Albuquerque Bernalillo County
Water Utility Authority

Development Review Board (DRB)
Review Comments
Utility Development Section
Reviewer: Blaine Carter, P.E.
Phone: 505.415.9188

DRB Project No:	Date:	Item No:
PR-2018-001405	7/13/22	#1 & 2
Zone Atlas Page: K-10	**Legal Description: Lot(s)** TRACT A-2 PLAT FOR TRACTS A-1 & A-2, NUEVO ATRISCO, TRACT B, NUEVO ATRISCO **Location:** 201 UNSER BLVD NW between CENTRAL AVE NW and SARRACINO PL NW.	
Request For: **SD-2022-01115 – AMENDMENT TO SITE PLAN** **VA-2022-00165 – SIDEWALK WAIVER** **SD-2022-00100 – PRELIMINARY/FINAL PLAT**

DRB Project Number: PR-2018-001405 AGENDA ITEM NO: 1 & 2
201 Unser - Nuevo Atrisco

Proposed

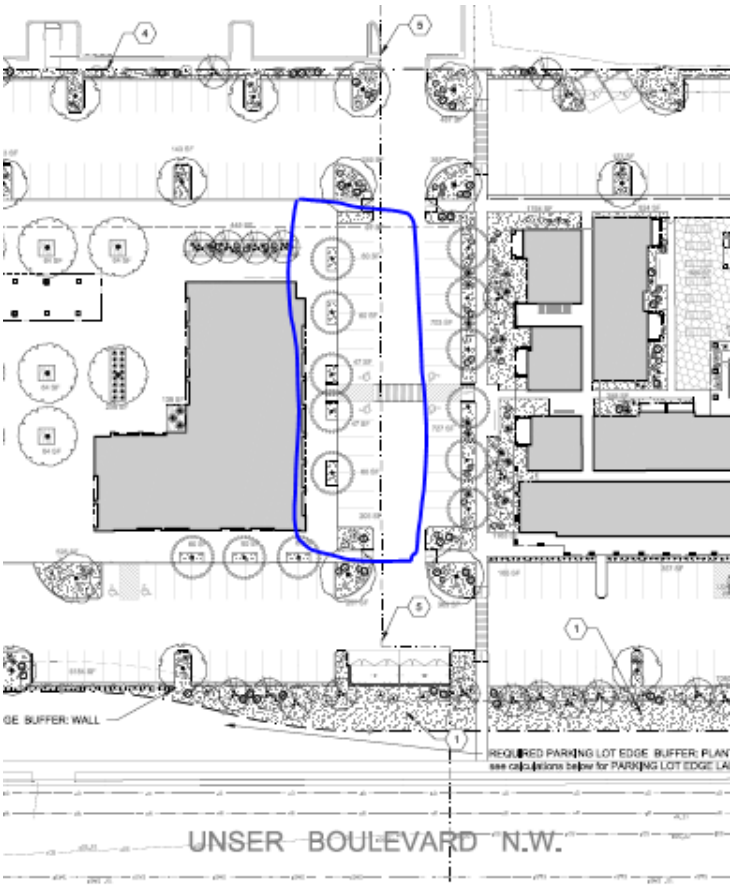
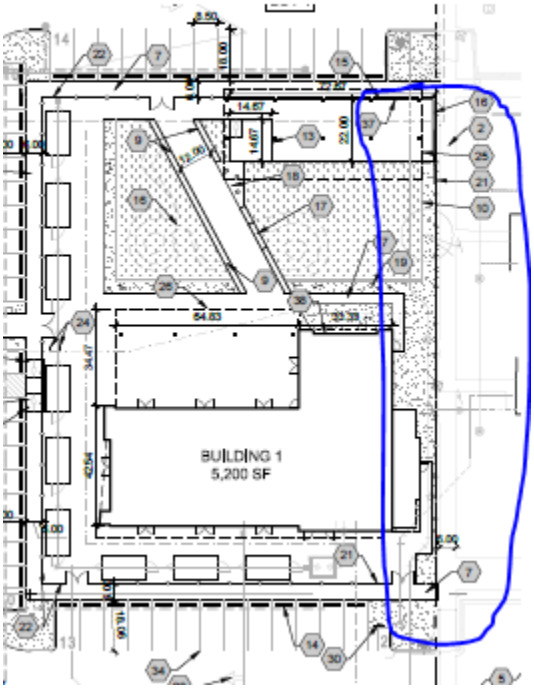
- **The applicant has added additional trees between the proposed commercial development and the existing multi-family residential development. The applicant also informed staff that the new site plan area for the food court covers the parking spaces and drive aisle that were formerly part of the multi-family.**
- ~~There is a row of trees on the existing Site Plan that provides some landscape buffer between the commercial and the multi-family. Please show how the proposed landscaping provides equivalent or better landscaped buffering to the multi-family development.~~
